Nine Mile Point
Nuclear Station

SUBJECT: Nine Mile Point Unit 1
Docket No. 50-220

Request for Additional Information (RAI) - Amendment
Application Re: Pressure-Temperature Limit Curves
(TAC Nos. MB6687 and MB6703)

**Response
to
NRC Request
for
Additional
Information:
Nine Mile Point
Unit 1
P-T Limit
Curves**

Figure 3-1 Average Fluence Rate for NMP-1 for Cycle 9 as a Function of Azimuthal Angle at the Maximum Axial Height Calculated Using Neutron Source Data from ORIGEN and from Casm-Simulate

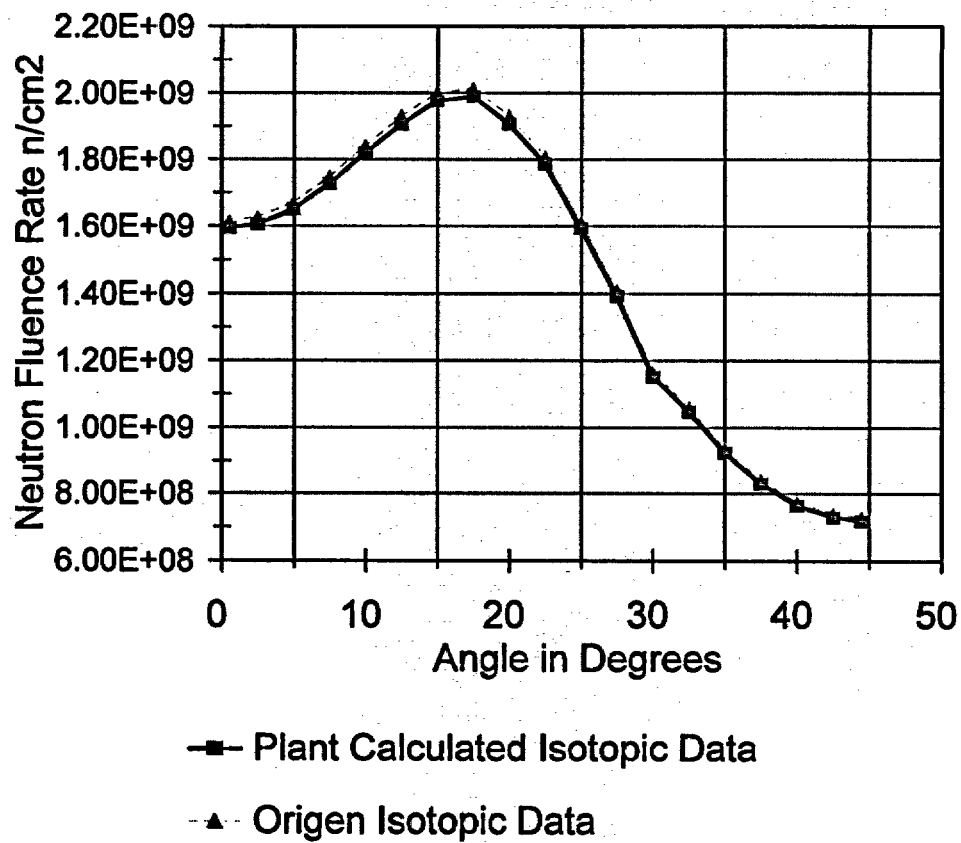
Benchmarking - The licensee derived the neutron sources using the power distribution and the ORIGEN 2.1 code. It is not clear to the NRC staff why this code was used since fuel composition as a function of burnup should be available from reload reports. Please justify the derivation of the source. For example, calculate a cycle for which you know the source would compare with results using ORIGEN 2.1.

Benchmarking - The licensee derived the neutron sources using the power distribution and the ORIGEN 2.1 code. It is not clear to the NRC staff why this code was used since fuel composition as a function of burnup should be available from reload reports. Please justify the derivation of the source. For example, calculate a cycle for which you know the source would compare with results using ORIGEN 2.1.

derived neutron source was higher by about 0.6%. Results for the two calculations are shown in Figure 3-1 which presents the neutron flux above 1 MeV at the vessel inner radius at the maximum axial elevation. It is observed that the curves are in close agreement, with the ORIGIN source producing a calculated fluence rate that is uniformly higher by 1.3%. Thus the effect of the difference in neutron spectrum is about 0.7% when the 0.6% difference in normalization is subtracted.

The 1.3% difference may be compared with the estimated uncertainty in vessel fluence due to the spectrum and normalization uncertainty previously evaluated for NMP-1 in Reference [2]. This estimate was 2.9% for the vessel inner radius maximum fluence rate. Thus, the difference between ORIGIN and Casmo-Simulate sources falls well within the previously estimated uncertainty. Moreover, it should be noted that the ORIGIN result differs in a conservative direction, i.e. use of the ORIGIN data produce a higher calculated exposure.

Based on these results, it is concluded that the use of ORIGIN to determine the fraction of fissions from fuel isotopes is acceptable in lieu of using plant-specific data from fuel depletion codes. If ORIGIN is used, differences within the range of burnups considered are less than estimated uncertainties in results arising from the uncertainties in neutron spectrum and source normalization, and the error is in a conservative direction.

Figure 5-1 Nine Mile Point Unit 1 R-θ Geometry Used in the DORT Calculations

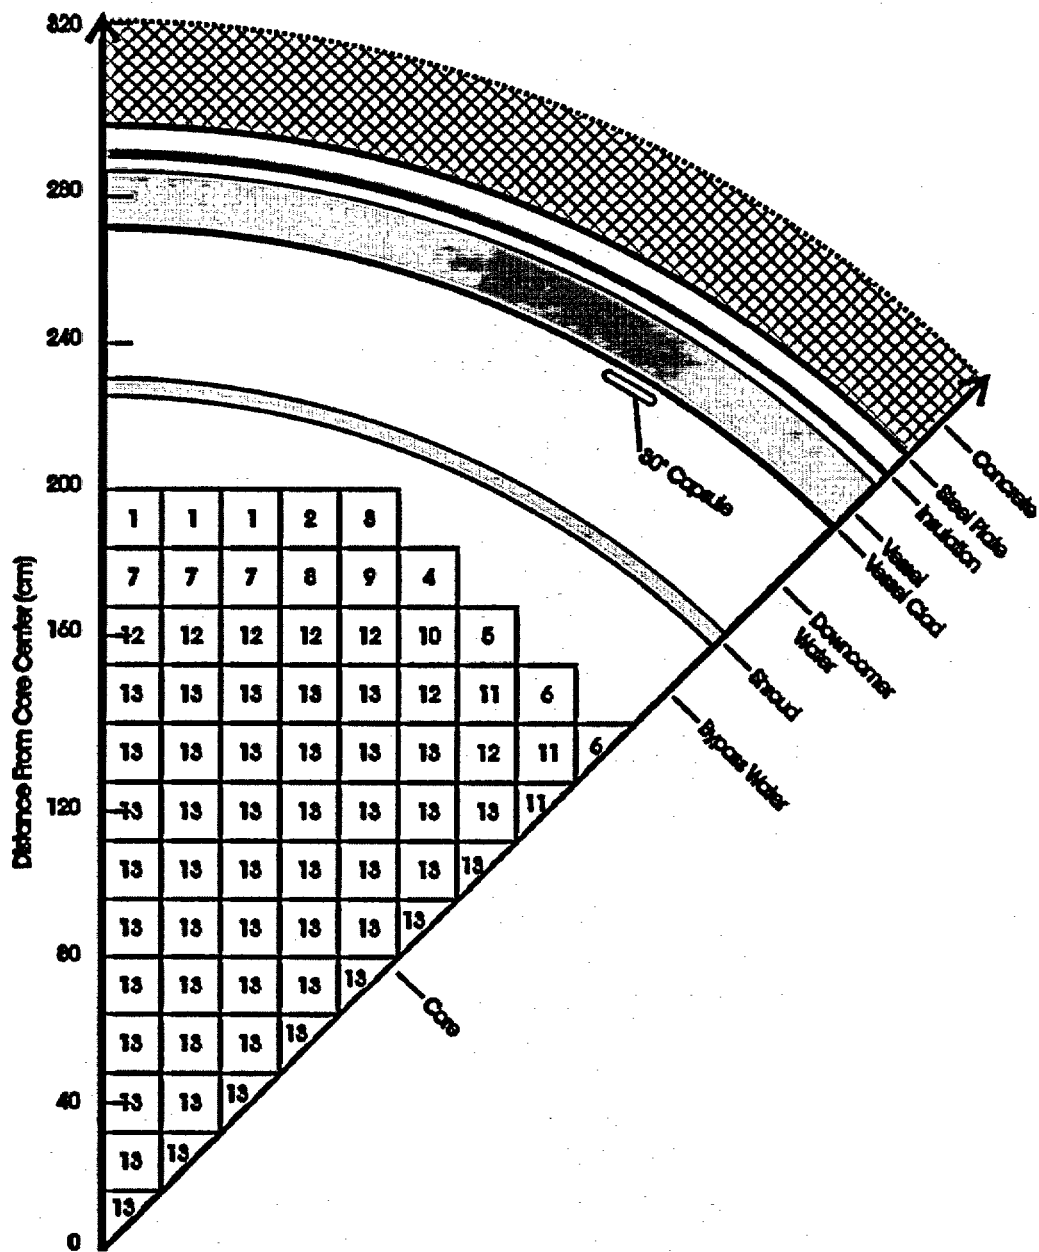
Surveillance Capsules Used in the Proposed Benchmarking - The licensee removed, tested, and analyzed a total of five surveillance capsules from both Nine Mile Point units. However, only two capsules were used in the submitted benchmarking analysis. As stated in RG 1.190, one of the objectives of benchmarking is to determine potential bias in the calculation of the best-estimate which requires that all of the existing data be used. The licensee ignored the existence of three Nine Mile Point capsules and made no effort to determine the existence of a bias. The benchmarking effort appears incomplete.

Surveillance Capsules Used in the Proposed Benchmarking - The licensee removed, tested, and analyzed a total of five surveillance capsules from both Nine Mile Point units. However, only two capsules were used in the submitted benchmarking analysis. As stated in RG 1.190, one of the objectives of benchmarking is to determine potential bias in the calculation of the best-estimate which requires that all of the existing data be used. The licensee ignored the existence of three Nine Mile Point capsules and made no effort to determine the existence of a bias. The benchmarking effort appears incomplete.

To perform the dosimetry analysis, updated models of the NMP-1 reactor were constructed. These models include the latest information available on the reactor geometry. Changes from earlier models include the use of plant specific data on regions above and below the core and definition of the regions beyond the vessel into the biological shield. Moreover, a more precise definition of the outer core edge and outer row of fuel bundles was incorporated into the model.

The R-θ model is shown in Figure 5-1. The model included 176 mesh points in the radial direction covering the range from the center of the core to about 12 inches into the concrete biological shield. In the azimuthal direction, 66 mesh points were used to model a single octant of the reactor. Inspection of the fuel loading patterns indicated that only minor deviations from an octant symmetry were present and thus use of a single octant in the model was justified. The core region used a homogenized material distribution which includes the fuel, fuel cladding, and the water. The water region in the fuel was divided into two parts: one with the water in the fuel bundle outside the pins, and one that included the water in the water pins and water in the channels outside the fuel bundle. The latter water was assumed to be all at the base water density with no steam fraction. The other water volume contains both liquid water and steam. The fraction occupied by steam is known as the void fraction and varies by fuel bundle and by axial position within the fuel bundle.
